Hydro One Networks Inc.

EB-2019-0082

OEB Staff Compendium

**Capital Expenditures and Transmission System
Plan Issues**

TSP-03-03, ISD-SR-19

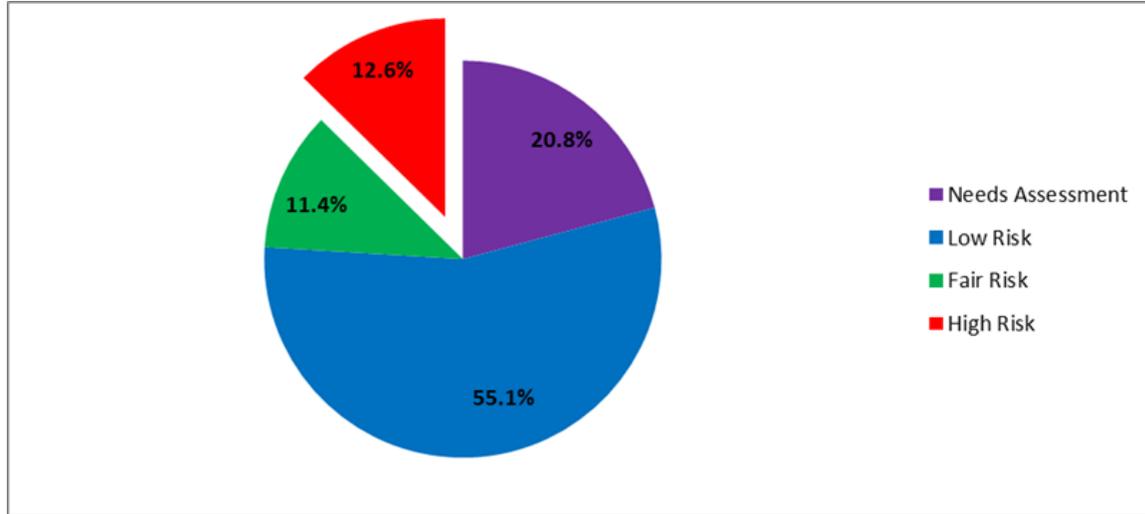
- a) Please confirm that the example in Figure 5 shows a failed splice rather than a failed conductor.
- b) Please compare the relative cost of replacing a sleeve or dead end fitting versus the cost of replacing 3 to 4 km of conductor (i.e. the distance between splices for typical reel lengths).
- c) Does Hydro One preferentially replace entire reels of conductor in situations where the conductor system deterioration is focused at sleeves and/or dead end fittings?

- a) As stated in ISD SR-19, page 7, Figure 5 shows a fallen conductor as a result of an insulator failure.
- b) The cost of replacing a single conductor connector is approximately 1/20th of the cost of replacing 3 to 4 km of conductor.
- c) Hydro One does not preferentially replace entire reels of conductor in situations where a conductor system's deterioration is verified to be isolated to a conductor connector.
